City of Shelton
Shelton Conservation Commission
54 Hill Street, Shelton, Connecticut 06484

RE: Towne Center at Shelter Ridge (#17-14)
LandTech Report

The Conservation Commission has reviewed LandTech's report dated September 10, 2019 for Towne Center at Shelton Ridge (#17-14) and offers the following comments:

Construction in areas west of the ridgeline would have a greater negative impact than construction along Bridgeport Avenue. (Image from the NRM report, originally prepared for Planning and Zoning application.)

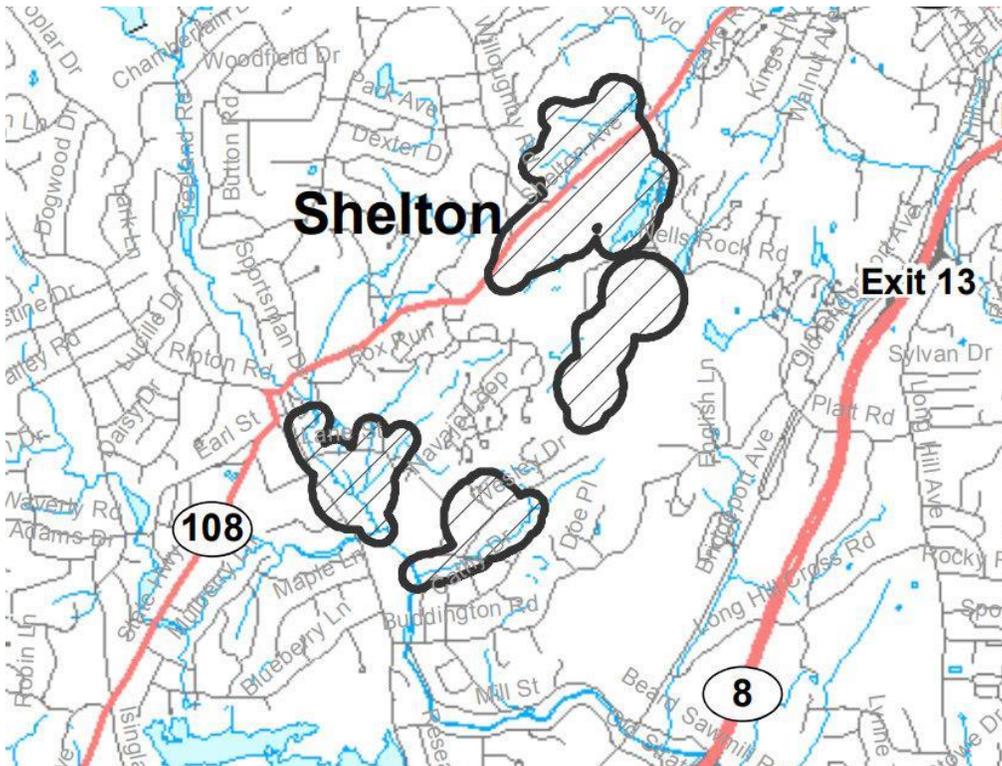
- 2. Prudent and Feasible Alternatives:** The NRM report stresses the importance of "Prudent and Feasible Alternatives," a cornerstone of the wetlands decision-making process, and recommends that construction activities be limited to the Bridgeport Avenue corridor as a reasonable alternative to the proposed site plan. The LandTech review lacks any discussion of alternatives. Some portions of the Shelter Ridge site are significantly more sensitive than others, as described in the NRM report. Specifically, the ridgeline and all land draining to the west of the ridgeline would have "high impact" if developed, while lands east of the ridgeline would have a lower impact (see graphic below). These

“high impact” lands drain either into the Vernal Pool Complex, which in turn drains into a stream containing a scenic waterfall on the adjacent open space, or directly into the Far Mill River, which is stocked with trout. This sensitive area is included as part of two designated greenways in the City’s 2009 Open Space Plan.
